# Access Compliance Report Public Rights-of-Way (Curb Ramps)

Main Street: WASHINGTON\_AVE Cross Street: BEACH\_BLVD Location: SE

ADA ID: RPRK220203162013 Ramp Type: Type 1 - Perpendicular Diagonal Initial Pass/Fail: Fail Overall Compliance: No Severity Score: 2

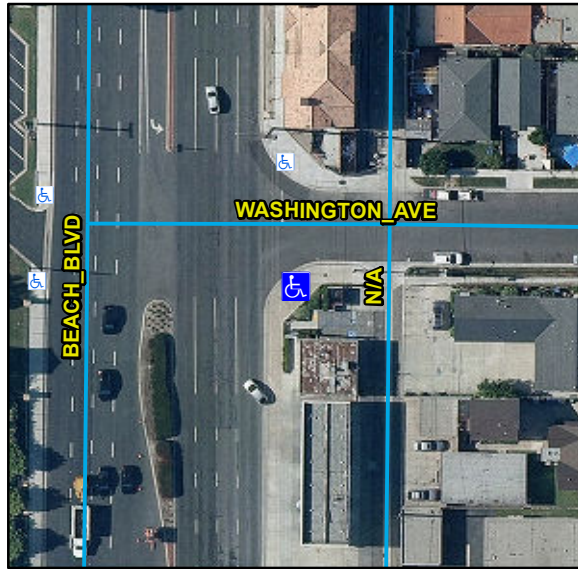
| Compliance | Description                           | Data | Compliance | Description                   | Data |
|------------|---------------------------------------|------|------------|-------------------------------|------|
| No         | Ramp Cross Slope (%)                  | 2.7  | N/A        | Flare Traversable LT          | N/A  |
| No         | Gutter Lip Height (in)                | 0.5  |            | Road Run Slope (%)            | 1.6  |

Remove & Replace Curb Ramp With Two New Directional Ramps or Equivalent. Grind Gutter Lip.
